**Stapleton Site A RFP Addendum 2**  
RFP Issue Date: December 18, 2020  
Pre-submission Conference Date: January 5, 2021  
Addendum 1 Issue Date: January 20, 2021  
Addendum 2 Issue Date: March 3, 2021

- A. Submission Instructions**
- B. Questions and Answers** – Enclosed are answers to questions sent to the RFP email address.
- C. DEC Permit Attachment** – Enclosed are drawings prepared for a New Stapleton Waterfront DEC Permit (see Questions and Answers section for details).

PERVIOUS / IMPERVIOUS  
AREA SITE PLAN

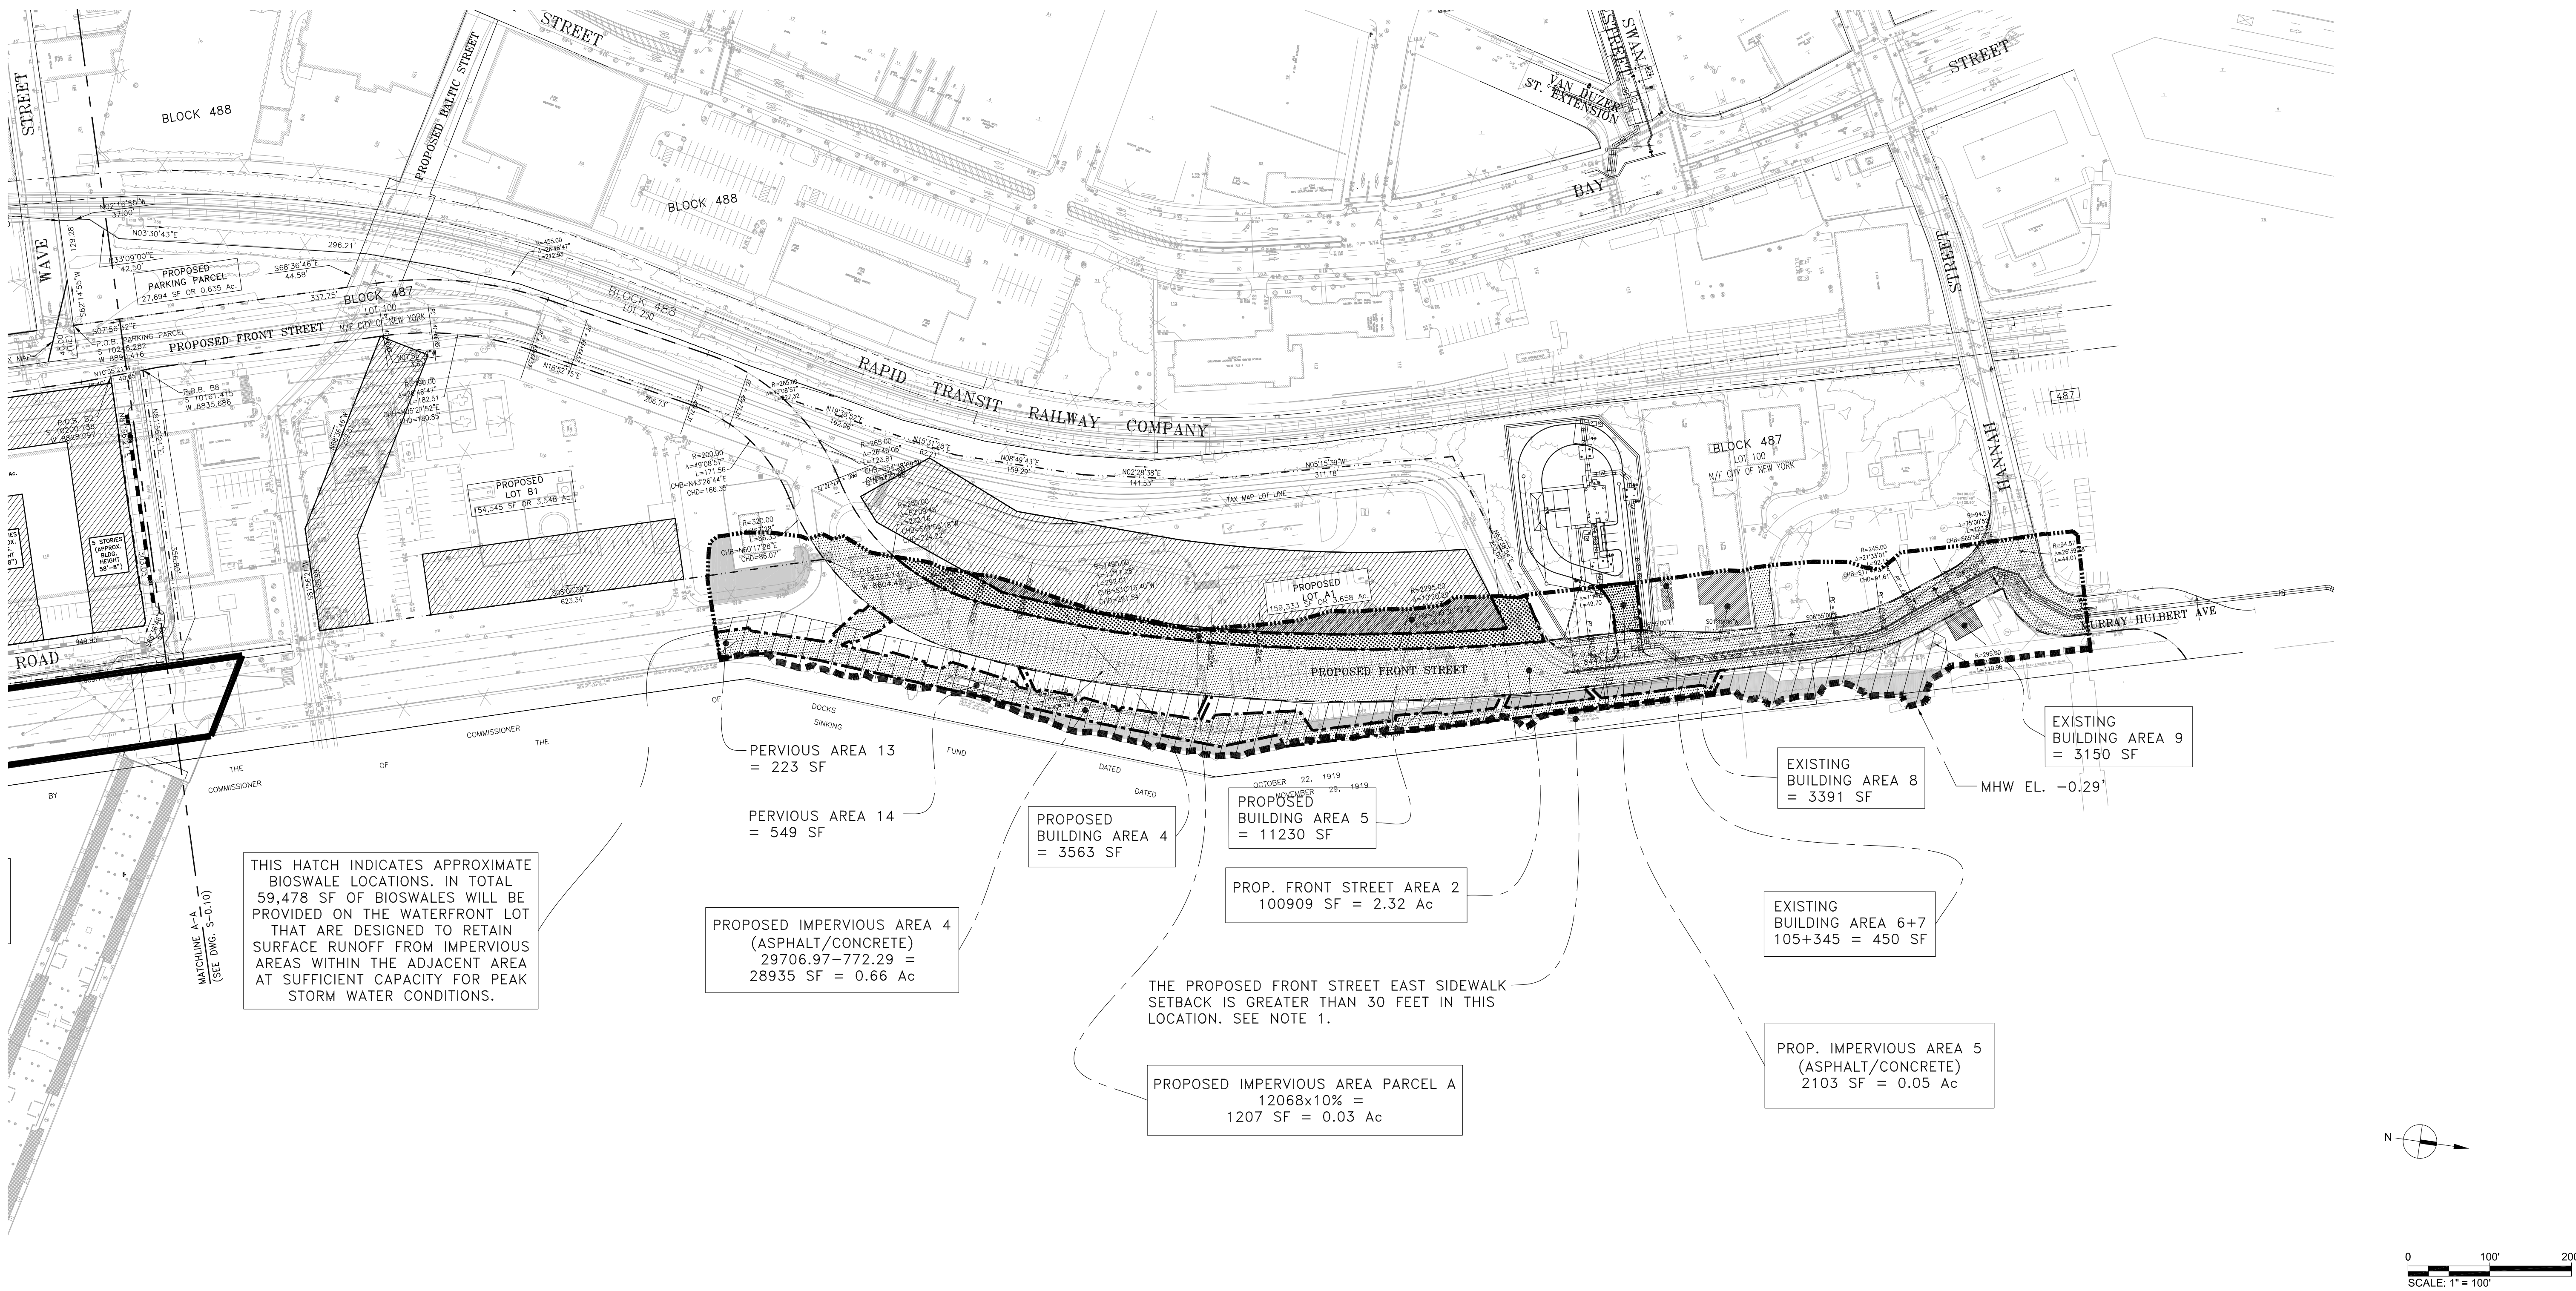
**Q: Can you provide the DEC tidal wetlands permits and drawings that were prepared for the New Stapleton Waterfront? Specifically, what is permitted and assumed for pervious versus impervious coverage on the subject site?**

For the purposes of applying to the RFP, please refer to the attached existing impervious and pervious area site plan and calculations for guidance ("DEC Permit Attachment"). These documents were prepared for the prior DEC Permit applicable to the New Stapleton Waterfront. Proposals that do not comply with these documents should indicate why it does not comply and outline any mitigation measures proposed within the DEC Adjacent Area. HPD anticipates that the selected development team will have to apply for a DEC permit for lot subdivision within the Adjacent Area and a partial permit re-assignment. HPD, EDC, and the City make no representations as to the accuracy of the documents provided herein or determination as to whether a Submission complies with any existing or required DEC permit application. As stated in the RFP, the Developer is responsible for obtaining all necessary governmental permits for the construction of the Project.
